Addendum No. 01

Project: New Police Station
City of Lacey
222 College Street SE
Lacey, WA 98503
City Project No. PW 2022-13

Issue Date: October 16, 2023

A GRADING SECTION "A"
SCALE: HORZ: 1" = 40' // VERT: 1" = 8'

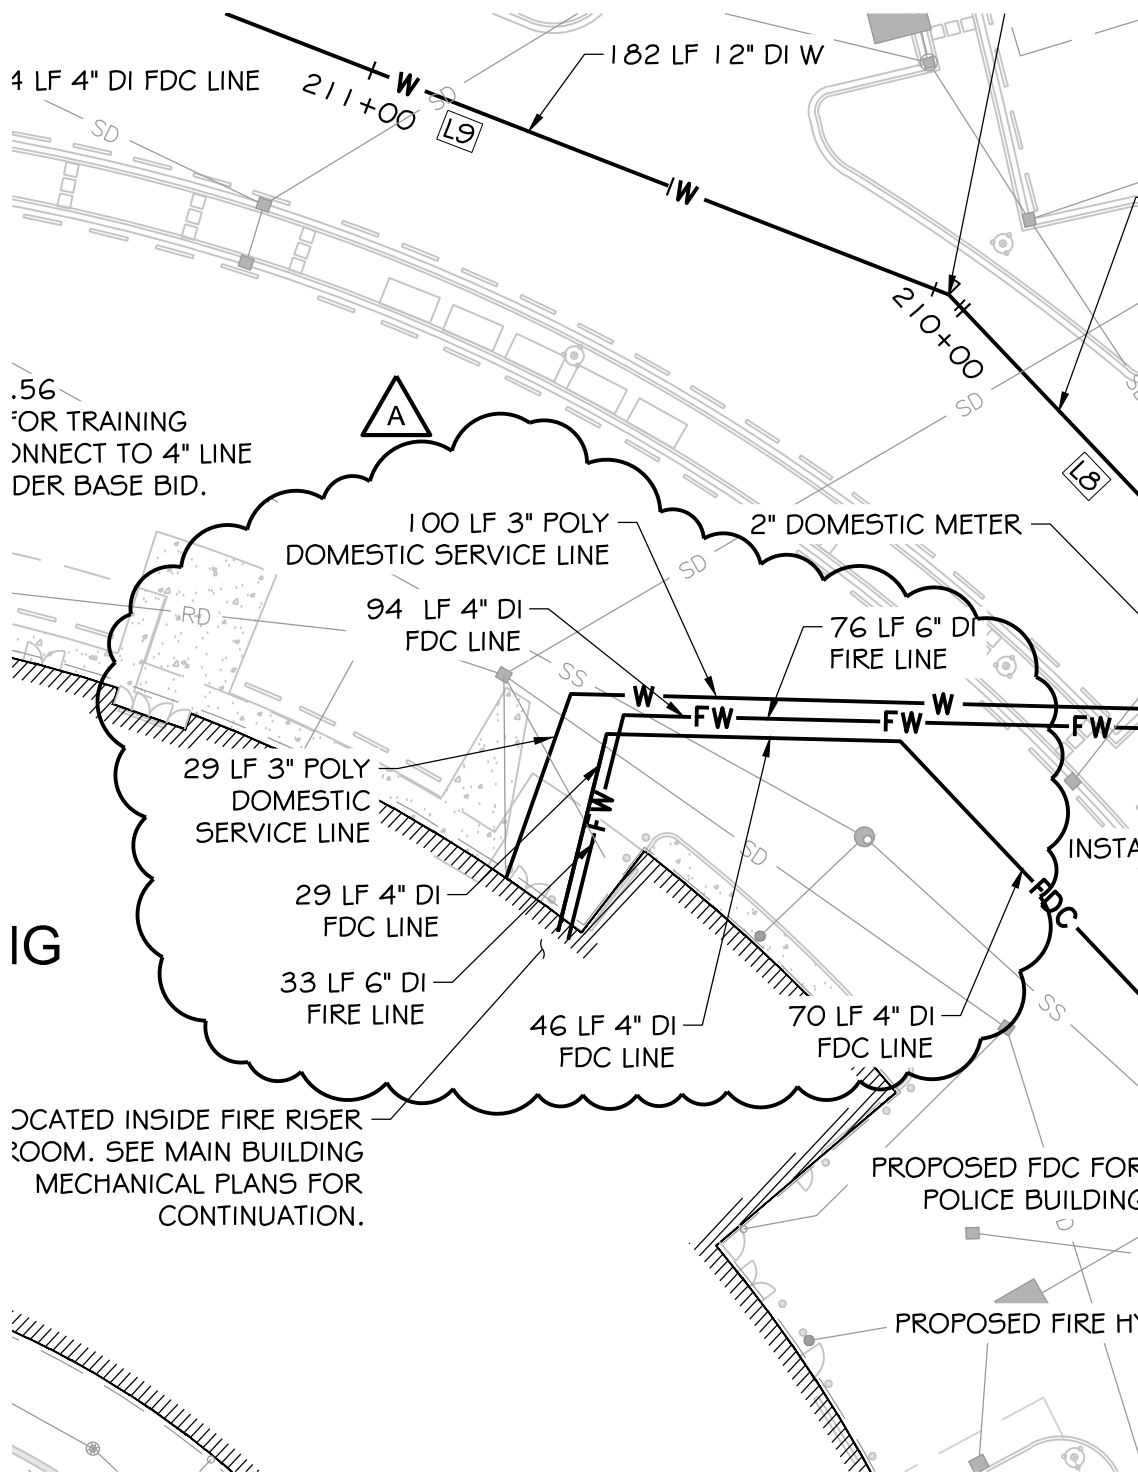
- 1) Replace Grading Section "A" with grading section on 11x17 sheet C-304-A1 attached to this Addendum including but not limited to changes noted below.
- 2) Update separation location between upper and lower floor of main building for clarification.
- 3) Add additional dimensions and slope callouts to area between eastern most curb and property line.

1 LOWER LEVEL FOUNDATION PLAN - WEST (PARTIAL)
SCALE: 1/8" = 1'-0"

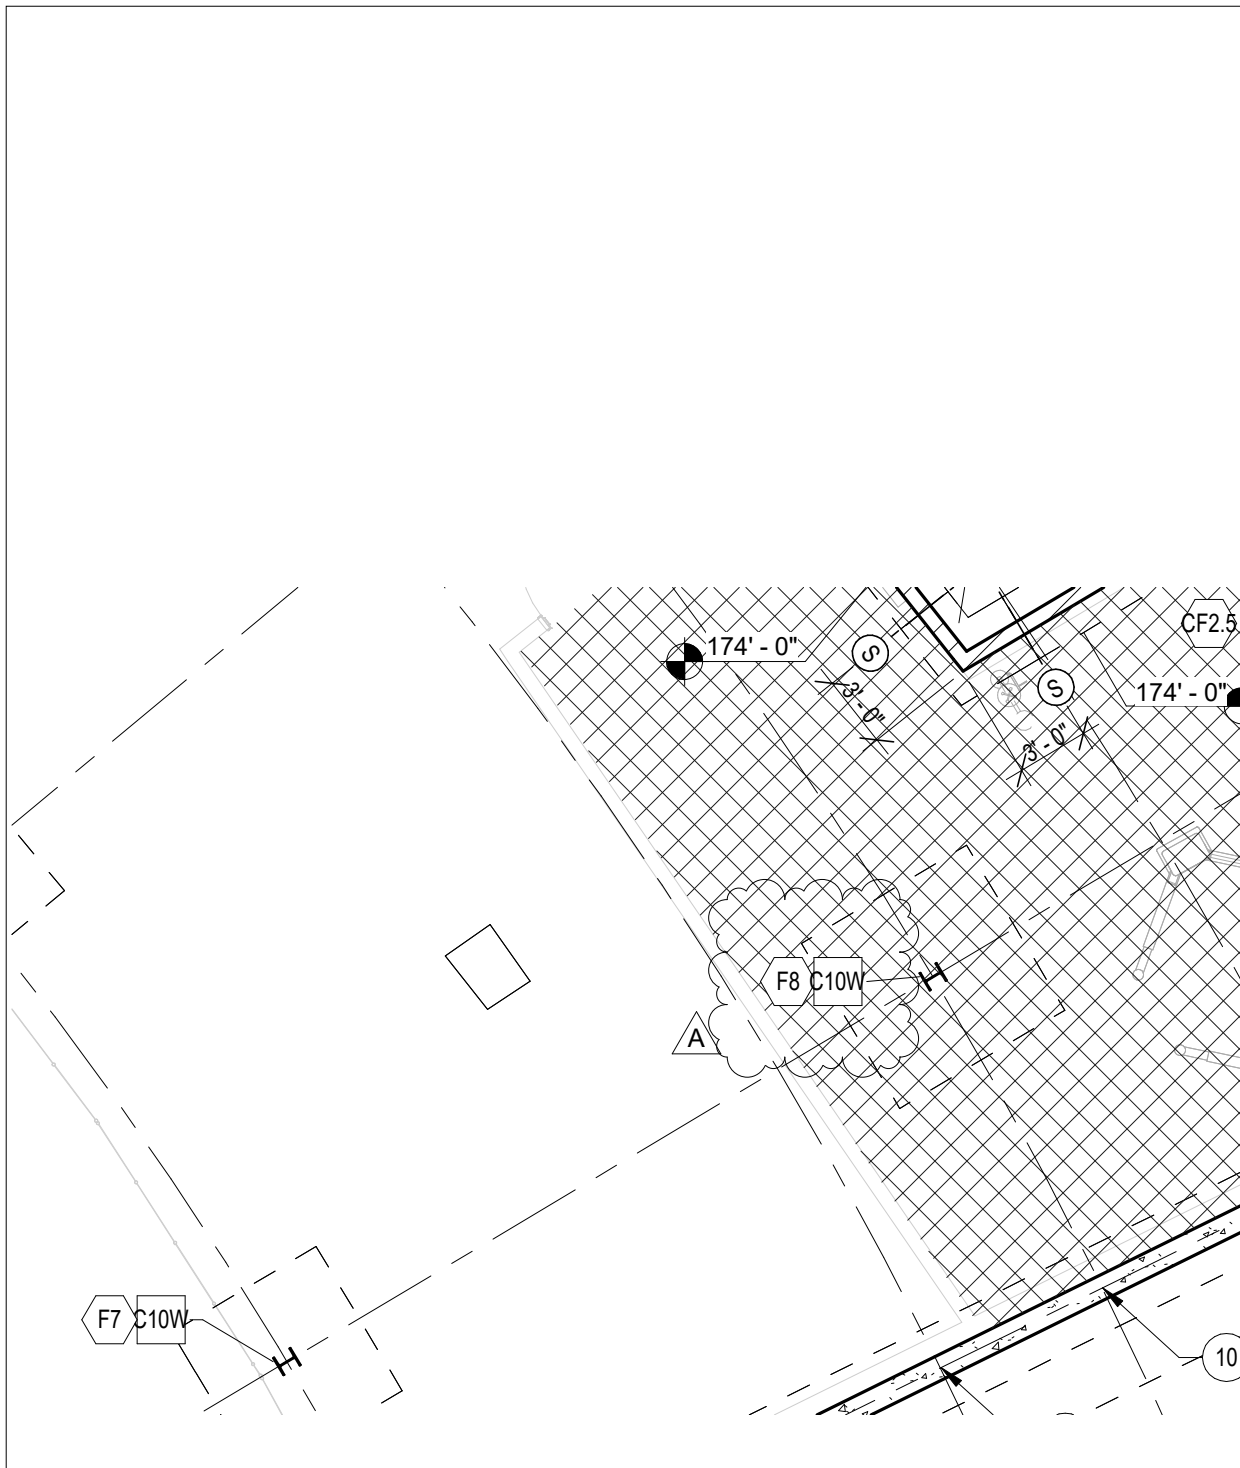
- 2) Update column size at grid E6 to mark C8 per 8.5x11 sheet S-111-A1 attached to this Addendum.

- 3) Update column size at grid E7 to mark C8 per 8.5x11 sheet S-111-A1 attached to this Addendum.

S-112-A1
LOWER LEVEL PLAN - EAST

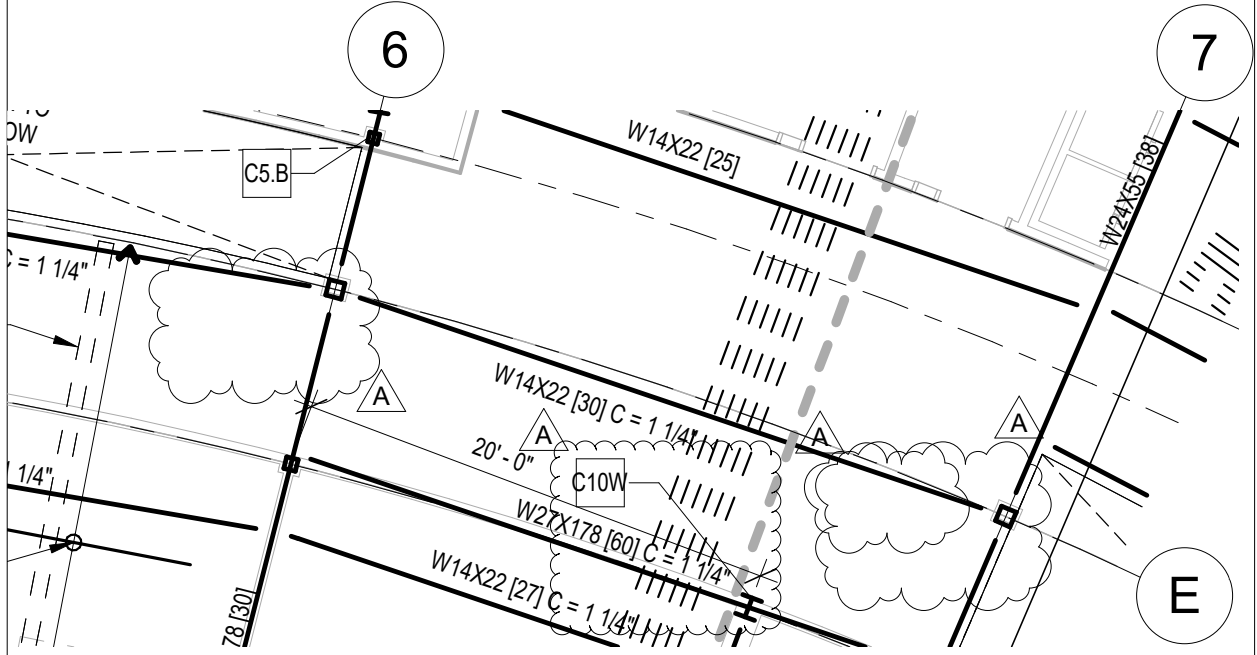
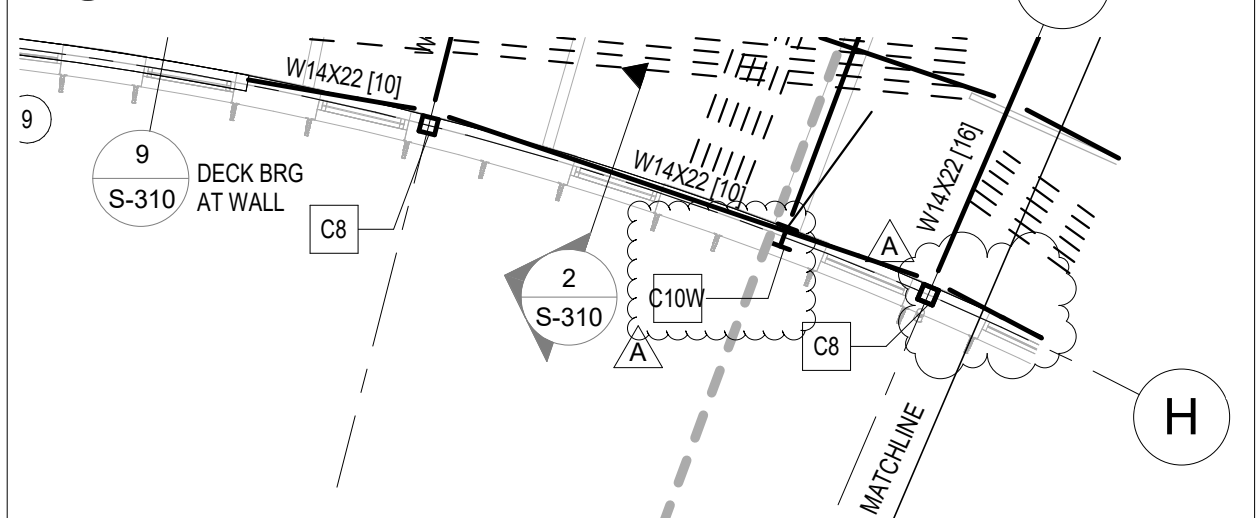
- 1) Revise column schedule to eliminate C10 and C14W per 8.5x11 sheet S-001-A1 attached to this Addendum.
- 2) Update column size at grid E7 to mark C8.
- 3) Add column tag (mark C10W) at grid F11 per 8.5x11 sheet S-112-A1 attached to this Addendum.

S-118-A1
CLT PANEL LAYOUT PLAN -
EAST

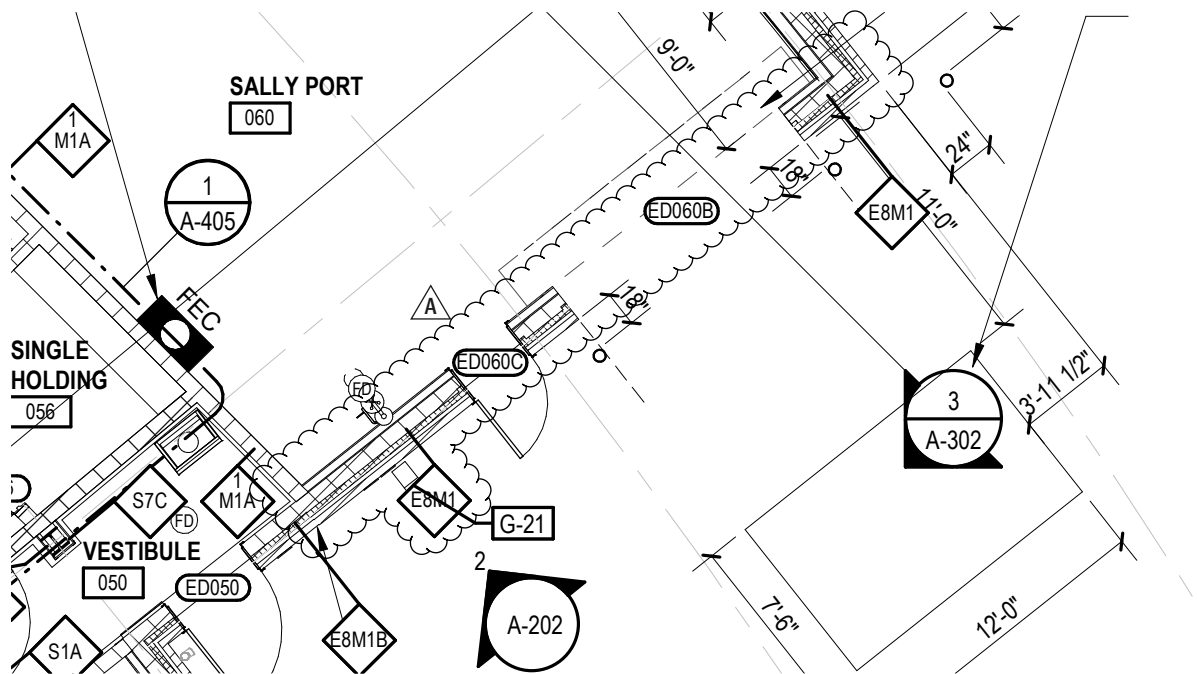
- 1) Revise roof overhang extents adjacent to grid 9 per 8.5x11 sheet S-118-A1 attached to this Addendum.

A-113-A1
UPPER LEVEL - ENLARGED
FLOOR & SYMBOL PLAN -
WEST

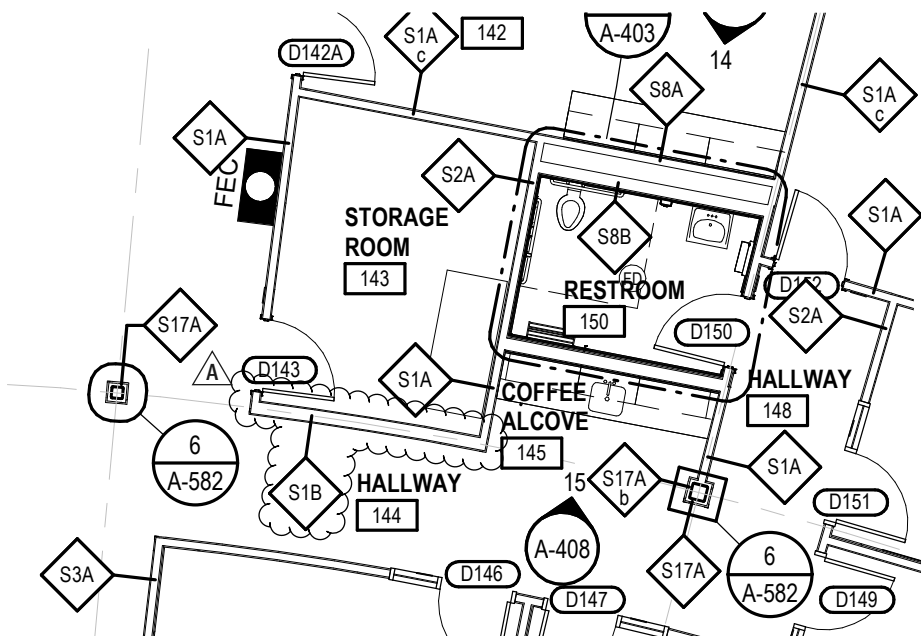
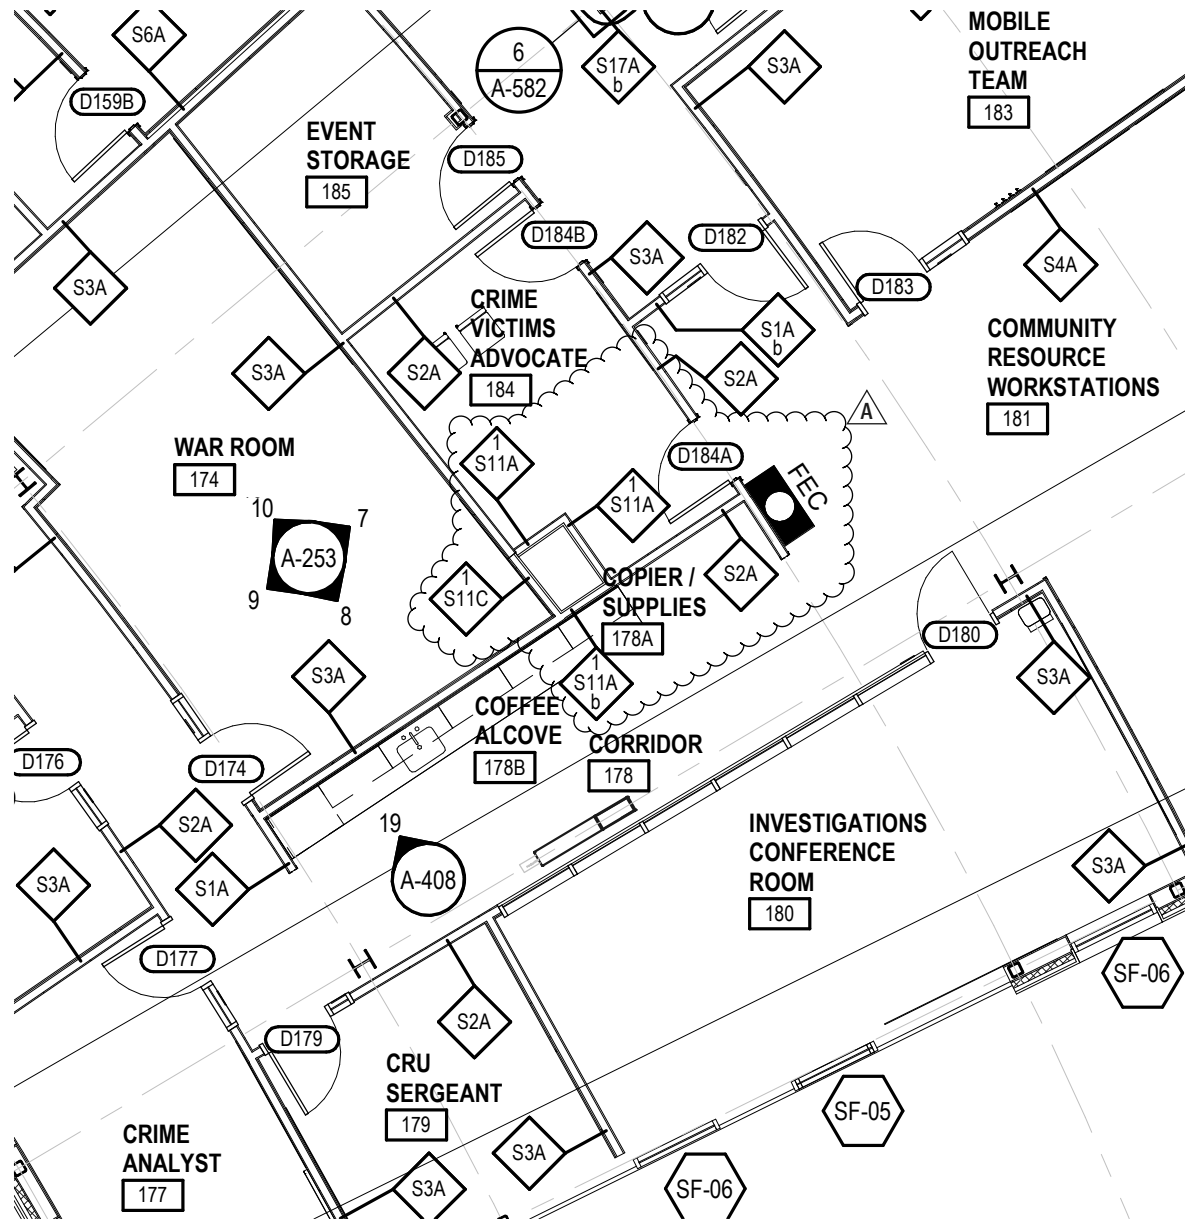
- 1) Room 105C EOC Storage: revise wall type of west wall to "S9B" per 8.5x11 sheet A-113-A1 attached to this Addendum.
- 2) Room 105C EOC Storage: add wall type symbols "S9A" north and south of EOC Storage wall to clarify change in wall type per 8.5x11 sheet A-113-A1 attached to this Addendum.
- 3) Room 143 Storage Room: revise wall type of south wall to "S1B" per 8.5x11 sheet A-113-A1 attached to this Addendum.

DATE: 10.16.2023
ADDENDUM NO. 01
SHEET NO.
A-154-A1
UPPER LEVEL - REFLECTED
CEILING PLAN - EAST

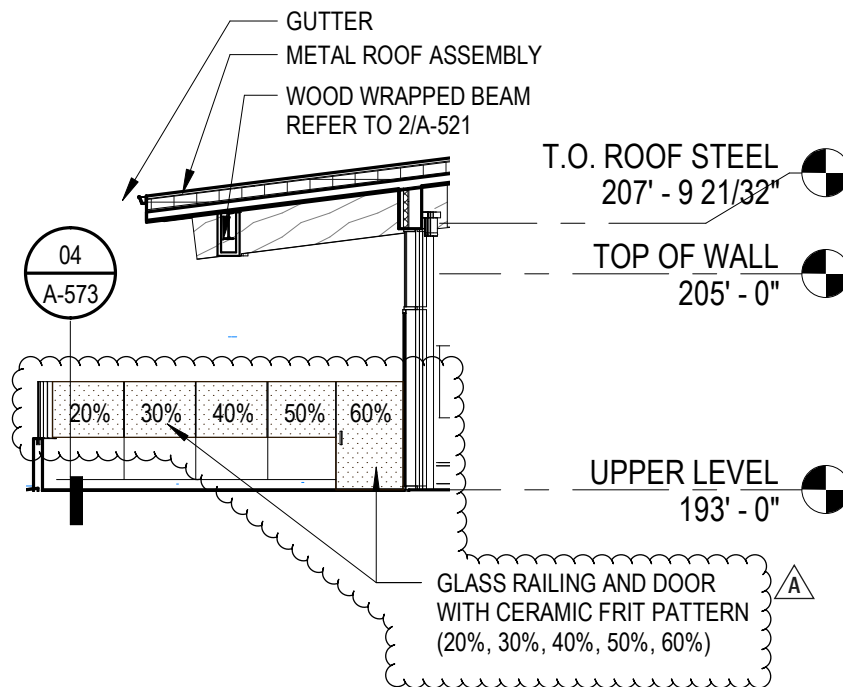
- 1) Room 178A Copier / Supplies: revise reflected ceiling plan wall layout per 8.5x11 sheet A-154-A1 attached to this Addendum. Make modifications relative to all finishes and disciplines associated with this reflected ceiling plan change.
- 2) Room 183 Mobile Outreach Team: replace ceiling type "ACT-1" with "ACT-3" per 8.5x11 sheet A-154-A1 attached to this Addendum.

9 BREAK ROOM PATIO- W
3/32" = 1'-0"

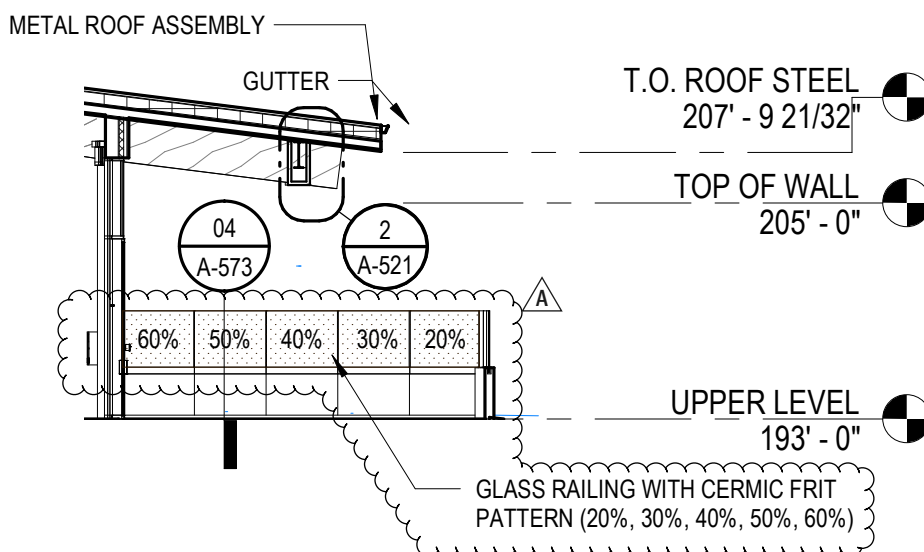
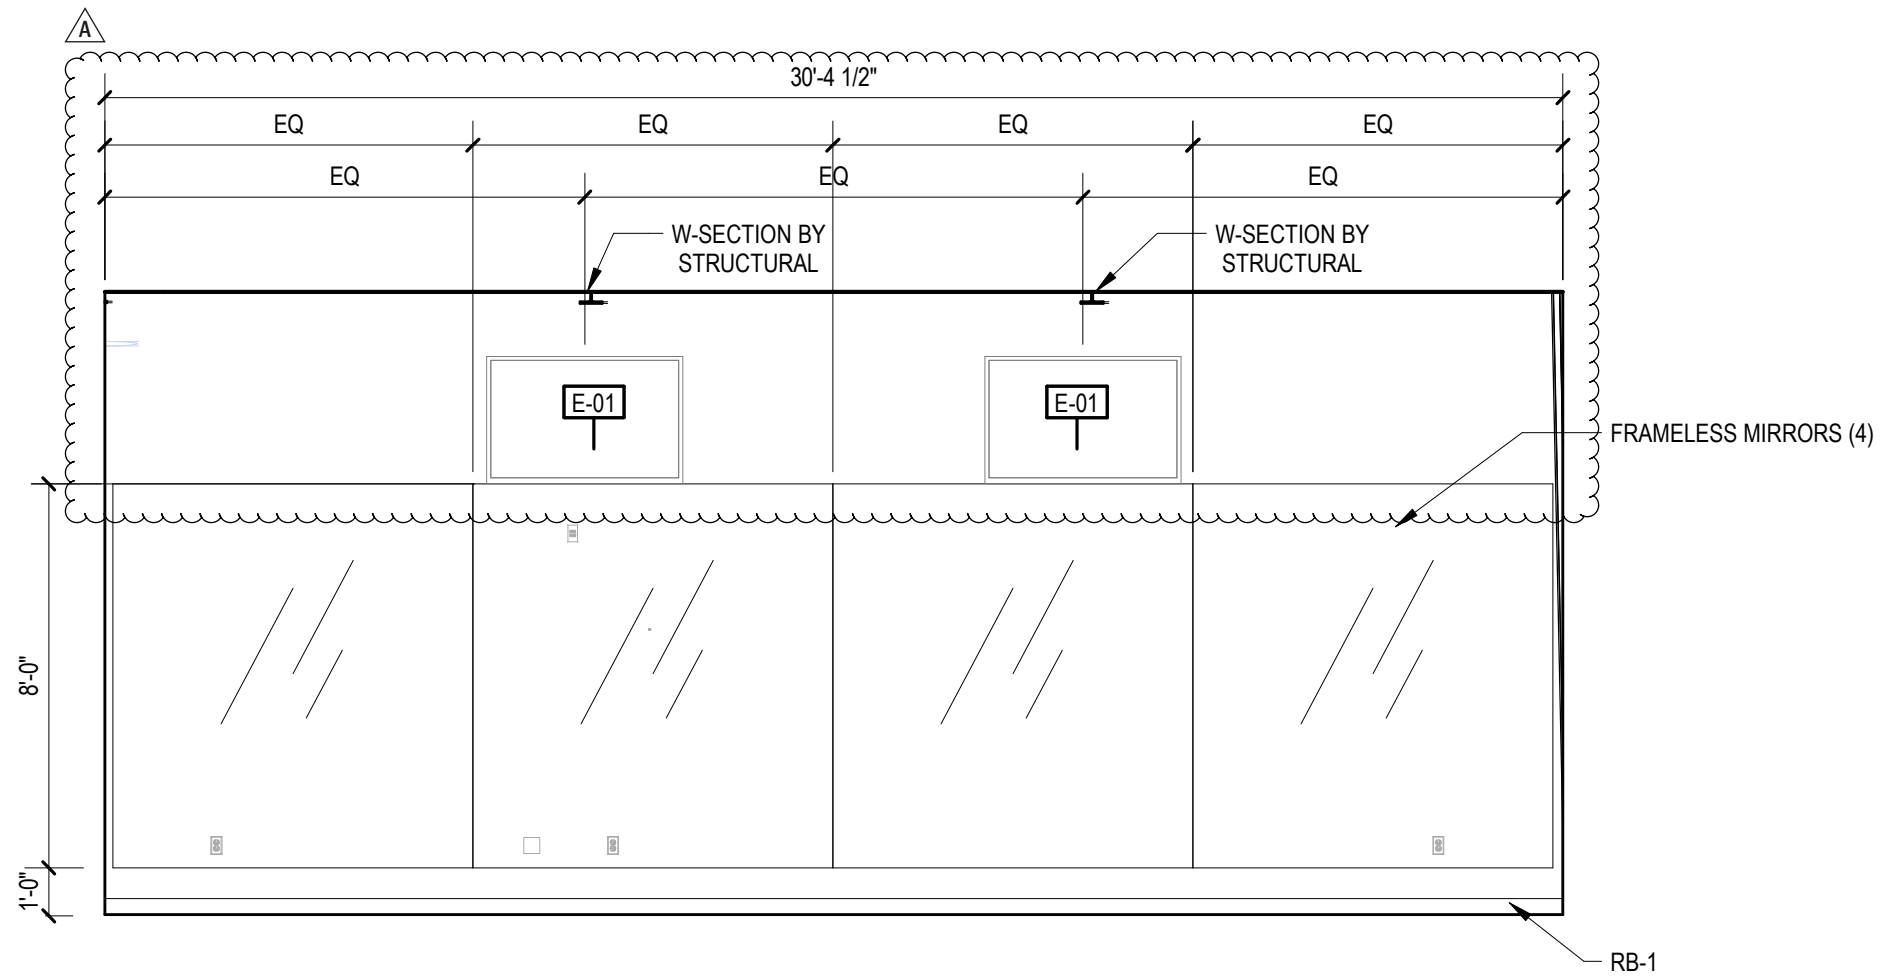
- 2) Detail views 9 and 11: add notes to graphic hatch per 8.5x11 sheet A-202-A1 attached to this Addendum: "Glass railing [and door] with ceramic frit pattern (20%, 30%, 40%, 50%, 60%)"
